FCC Class II Permissive Change Request Letter

RE: FCC Permissive II Change Request for Company: TCL OVERSEAS MARKETING LTDFCC
ID:2AZVS-B600A

PD41S_Difference content

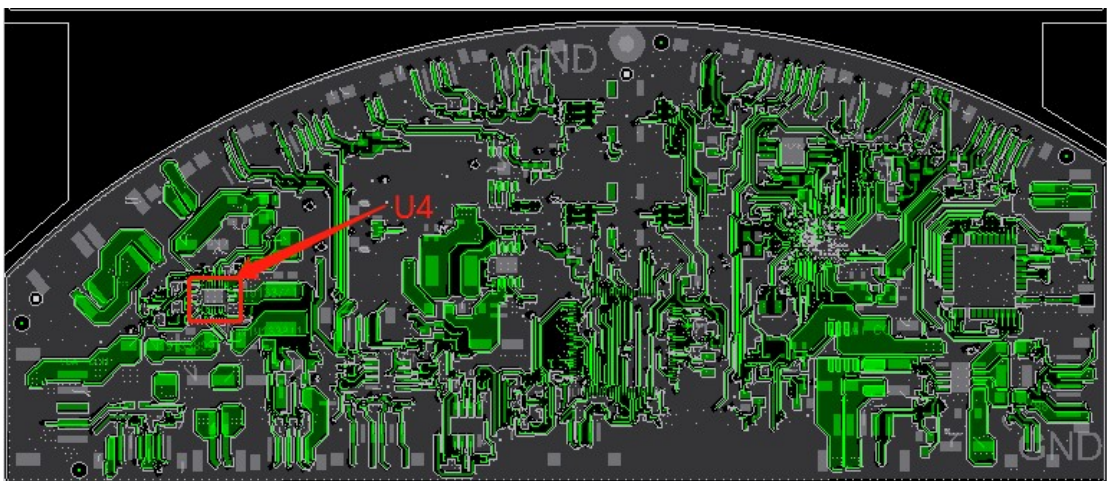
- 1、 Q28 and q34 are adjusted from rc3407 to dtm4417 (Q44 and Q45)

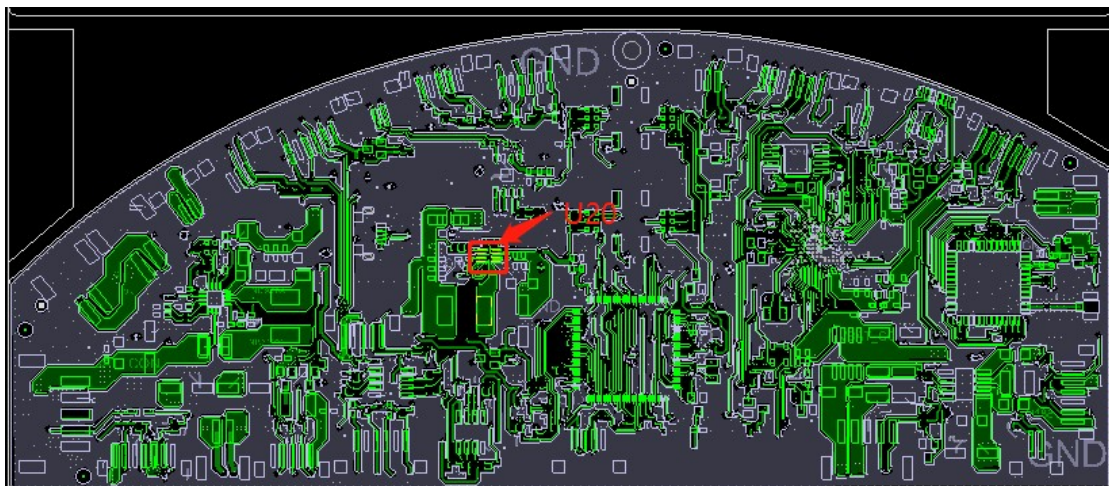
- 2、 The charging IC is adjusted from sc89171 (U4) to mp26124 (U19)

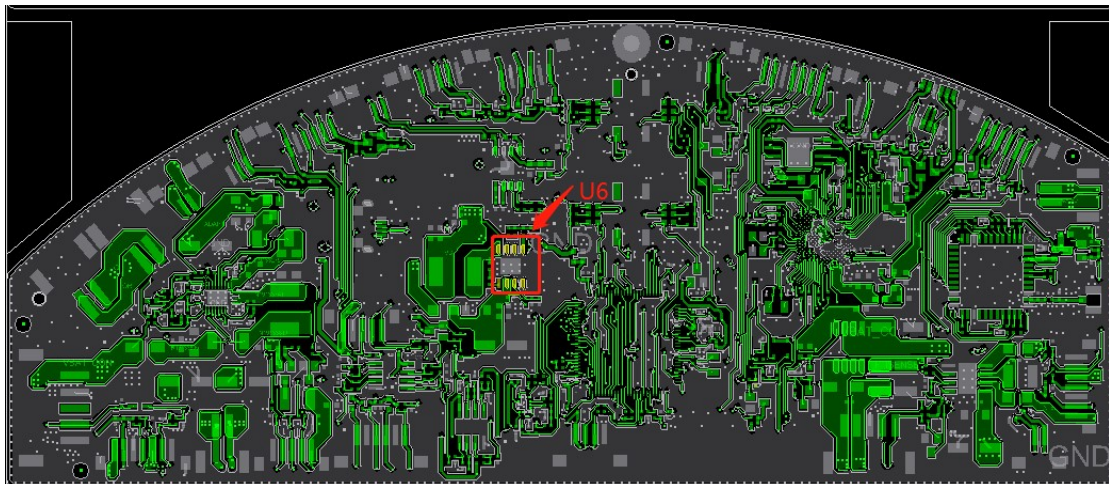
3、 DC-DC is adjusted from sct9330 (U6) to mp2395 (U20)
